Access Compliance Report Public Rights-of-Way (Curb Ramps)

Main Street: ELM_PL Cross Street: SPRING_VIEW_WAY Location: SE

ADA ID: RPRK211019140504 Ramp Type: Type 4 - Parallel Initial Pass/Fail: Fail Overall Compliance: No Severity Score: 30

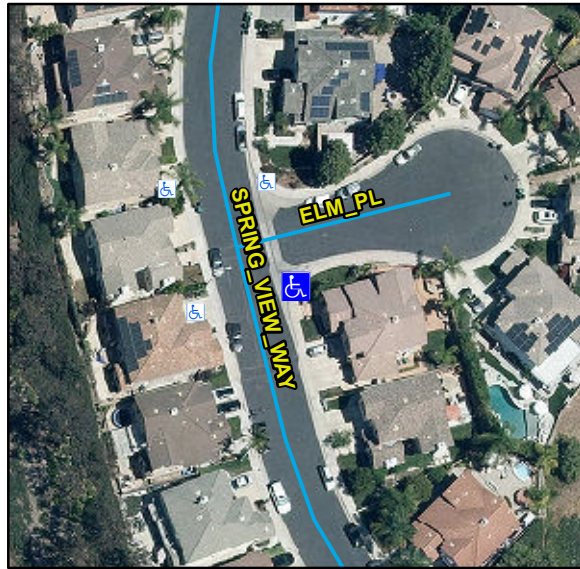
Codes/Mitigation Info/Possible Solution

R304.2.2, R204.3, R304.5.3, STD 1115

Compliance	Description	Data	Compliance	Description	Data
N/A	Ramp Length LT (in)	119	N/A	Ramp Length RT (in)	117
Yes	Ramp Width LT (in)	53	Yes	Ramp Width RT (in)	53
Yes	Ramp Run Slope LT (%)	3.9	Yes	Ramp Run Slope RT (%)	0.9
No	Ramp Cross Slope LT (%)	8.9	No	Ramp Cross Slope RT (%)	10.7
N/A	Landing Present	N/A	N/A	DWS Provided	N/A
N/A	Landing Length (in)	N/A	N/A	DWS Contrast	N/A
N/A	Landing Width (in)	N/A	N/A	DWS Length (in)	N/A
N/A	Landing Run Slope (%)	N/A	N/A	DWS Full Width	N/A
N/A	Landing Cross Slope (%)	N/A		DWS Offset Type	N/A
N/A	Landing Movement Obstructed?	N/A	N/A	DWS Offset Left (in)	N/A
	Landing Movement Type	N/A	N/A	DWS Offset Right (in)	N/A
N/A	Landing Shared	N/A			
N/A	Clear Space	Yes			
N/A	Clear Space To Crosswalk (in)	N/A			
N/A	Marked Crosswalk 1	No	N/A	Marked Crosswalk 2	No
	Crossing 1 Direction	N		Crossing 2 Direction	W
N/A	Marked Crosswalk 1 Width (in)	N/A		Marked Crosswalk 2 Width (in)	N/A

Remove & Replace Curb Ramp With Two New Directional Ramps or Equivalent.
